SEABROOK STATION

Subject: Interim 10CFR50.55(e) Report; Solid State Protection System
Power Surge

NS-EPR-2638

SOLID STATE PROTECTION SYSTEM MASTER RELAY AND OUTPUT RELAY TEST

SIMPLIFIED SKETCH OF TYPICAL SAFEGUARDS ACTUATION RELAY TESTING IN THE SSPS

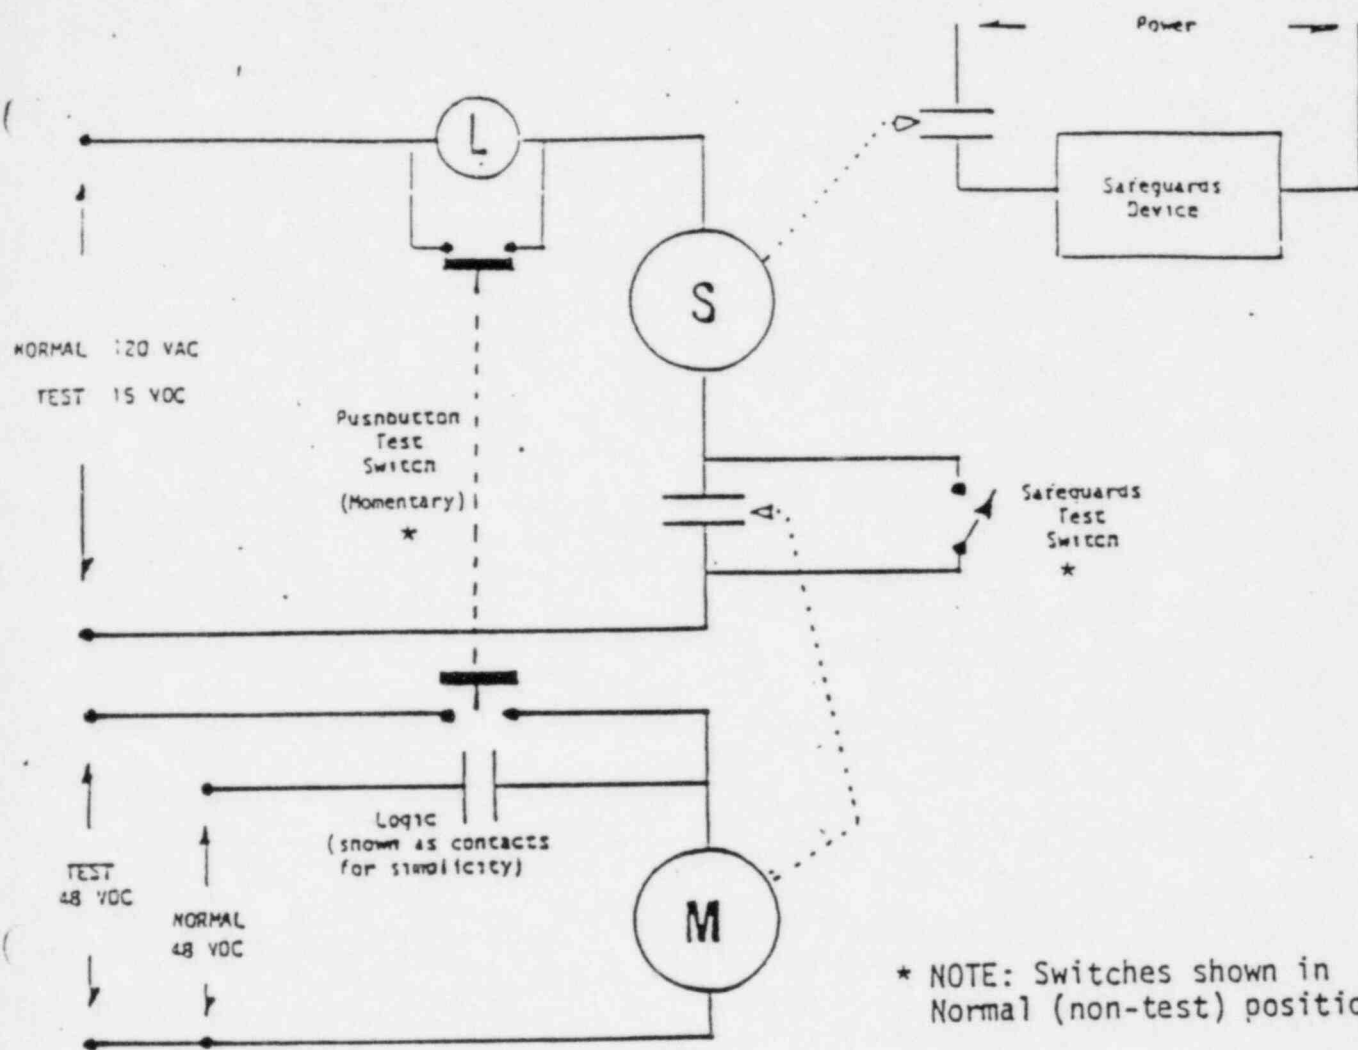
During review of a schematic diagram of the Solid State Protection System (SSPS), redrawn for purposes of consolidation, Westinghouse engineers uncovered an undetectable failure which could exist in on-line testing circuits for relays in the system.

As mentioned above, output relay coil continuity is confirmed at the SSPS, without operating the relay, by reducing the circuit voltage to 15VDC from 120VAC. As shown in the sketch, operation of the master relay by means of the pushbutton test switch also removes the shunt from the SSPS proving lamp and allows the 15VDC to energize it to confirm the continuity of the output relay coil.

Upon completion of the master relay and output relay coil continuity tests, 120VAC circuit voltage is restored. However, if the switch contacts which shunt the proving lamp should fail to reclose as expected, 120VAC would be applied to the lamp in event the system were called upon to operate. Depending on the output relay coil impedance and the number

of output relays being operated by the master relay contacts, the current through the lamp could cause it to burn open before the output relay(s) energized. In such an instance associated Safeguards devices in the affected train would not actuate. Since, during circuit analysis, all identified nondetectable failures must be assumed to have occurred, the redundant Safeguards actuation train must be assumed to be similarly, if not identically, failed.

PROBLEM: If contacts shunting proving lamp L do not reclose when pushbutton is released and system is return to Normal, then 120 VAC would be applied to Slave relay coil thru the proving lamp if Safeguards actuation were called for by the Logic "contacts".

Although failure of the subject test switch contacts is highly improbable, Westinghouse is recommending a minor revision to test procedures conducted from the Safeguards Test Cabinets where operation of the SSPS output relays is verified. The revision will ensure that the relay test circuits in the SSPS operated properly when the system was returned to its normal operating mode. The procedure changes are described in Attachment III and are recommended until Westinghouse completes a review of its consideration of design changes.

Perform the test described below immediately following completion of the Solid State Protection System (SSPS) Output Relay Testing.

This test will ensure that the pushbutton or relay contacts used to shunt the output relay continuity lamps located on the Output Relay Test Panel have returned to the closed position.

6. If an output relay continuity lamp illuminates during testing from the STC it is an indication that the lamp's shunting contact is open. Should this occur, remove the associated SSPS logic train from service and replace the Output Relay Test pushbutton (for "new" 2-train and 3-train SSPS, replace the relay whose contacts used for shunting the lamps failed to close). After replacement, retest the master and output relays from the Output Relay Test Panel and perform the tests listed above.
